FCC Class II Permissive Change Request Letter

RE: FCC Permissive II Change Request for Company: Inlumen Technologies Co., Ltd. FCCID:2BHFB-QUEST-00

We, Inlumen Technologies Co., Ltd., Product name: **QUEST Thermal Imaging Binoculars** (FCC: 2BHFB-QUEST-00, Granted on: 06/24/2025). The prototype has the same RF design except:

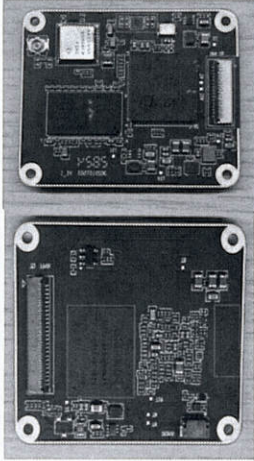
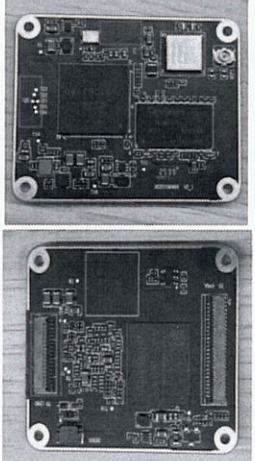
QUEST H50R/QUEST H35R/ QUEST L35R	QUEST S50R	Change Point
Main Control Board			The connection to the camera module has been changed from a DVP interface to an MIPI interface; the camera connector has been updated from a 33-pin to a 35-pin version and relocated from the top layer to the bottom layer; the eMMC component model has been replaced; component layout has been optimized; and capacitor values have been optimized.
Camera Module Adapter Board		/	Eliminate the camera module adapter board
Camera module flexible cable			Add a board-to-board connector to the cable, and mount an IMU and SMD resistors/capacitors.
Power supply board			Change the values of two resistors, both to be smaller; all other aspects remain the same.
